Access Compliance Report

Public Rights-of-Way

(Curb Ramps)

Intersection ID: 49932	Main Street: WOBURN_RD	Cross Street: PAXTON_RUN_RD	Location: SE
ADA ID: 501A3B50F539	Ramp Type: Perp	Initial Pass/Fail: Pass	Overall Compliance: No
Severity Score: 0			
Codes/Mitigation Info/Possible Solution		Field Measurements/Component Compliance

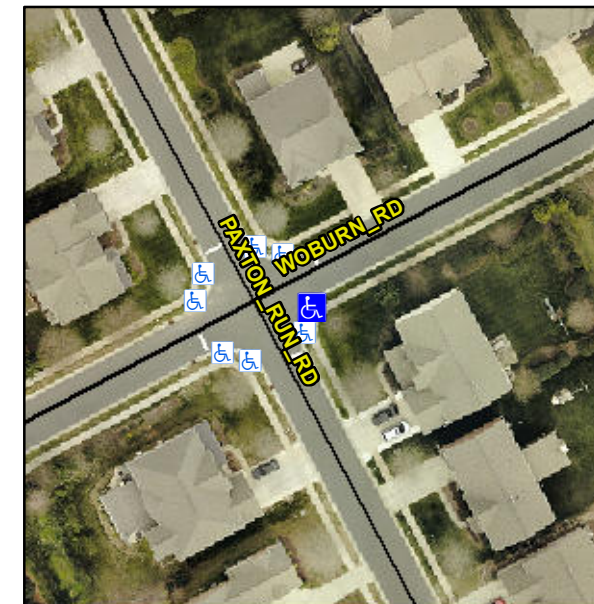
Not Found, R305.2

Remove & Replace Entire Ramp.
